LUMINARY Memo #148

To: Distribution
From: B. McCoy
Date: 11 May 1970
Subject: Call It LUMINARY 1D

Revision 163 of Luminary was released on 5/5/70 for manufacture. It contained a total of 39 PCRs, 6 PCNs, 15 ACBs and 6 Anomalies. On the following pages is a detailed description of each implementation or a reference made where appropriate.

1027/1035

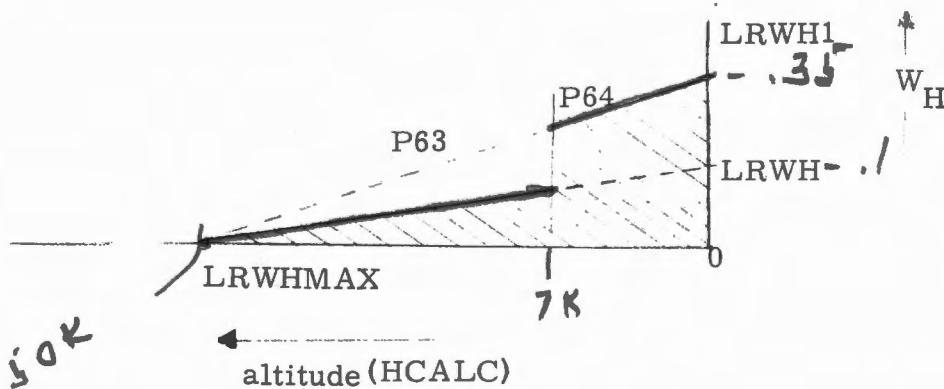
An a priori Terrain Model was implemented into Luminary to smooth the trajectory over rugged lunar terrain and to reduce the LPD errors and fuel consumption. It uses 5 segments, a slope and a range-to-landing site (abscissae), for each. The terrain not falling into the segmented region

(the model covers a region from some specified abscissae (range) to the landing site) will be modelled by a constant altitude, equal to the altitude at the last abscissae. The slopes and abscissae are specified in E memory by SLOPE0, 1, 2, 3, 4 and ABSC0, 1, 2, 3, 4. SLOPE_H and ABSC_H correspond to the segment nearest the landing site (loc E5, 1527 and E5, 1522 respectively, scaled B-6 and B-18 respectively). For more details see Luminary Memo # by Allan Klumpp, Don Eyles, and Bruce McCoy.

FIGURE 2

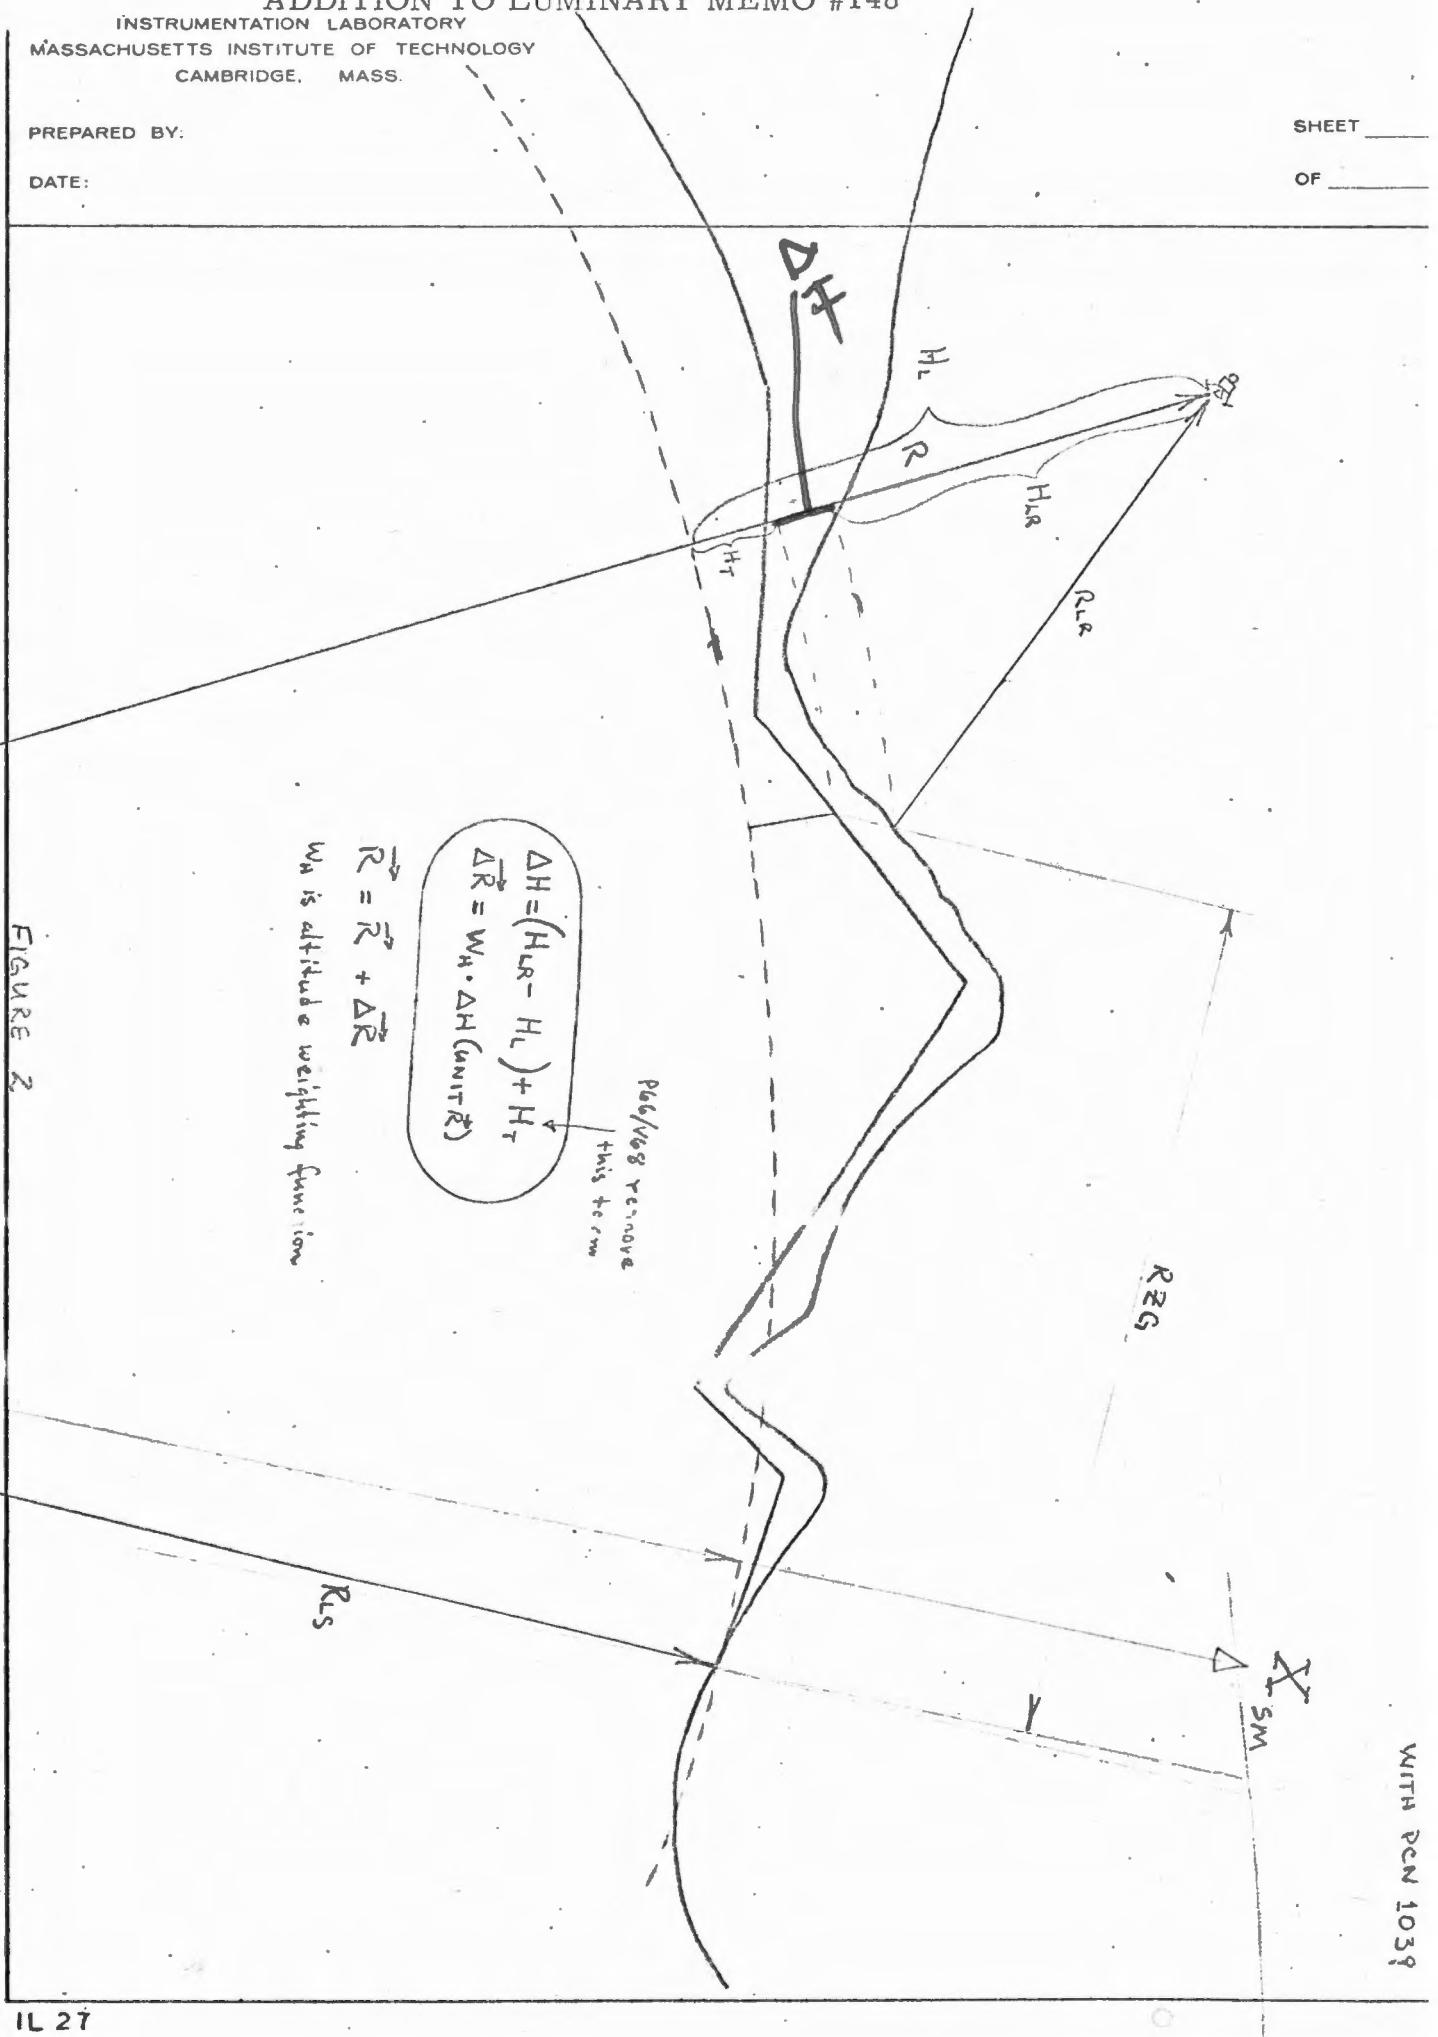
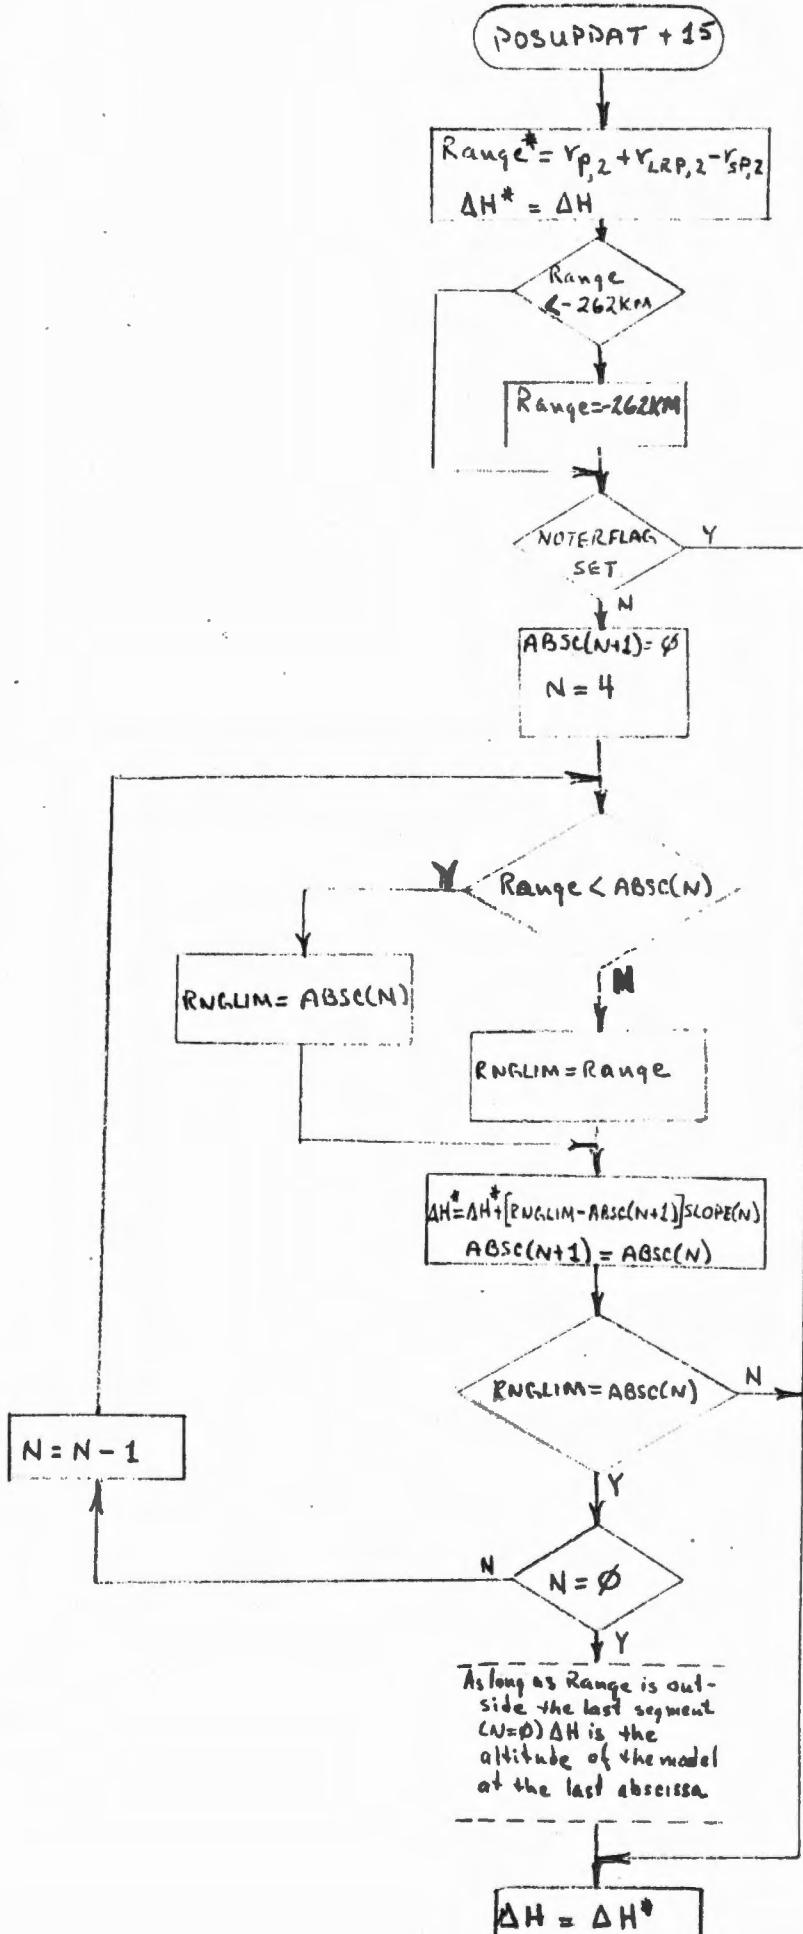
A PRIORI TERRAIN MODEL

Range is a negative number equal to the Z component in platform coord of the vector from the Landing Site to the point of intersection of the LR altitude beam with the lunar Surface.

If the Range is within the segment for this pass, ΔH is the altitude of the model at this Range
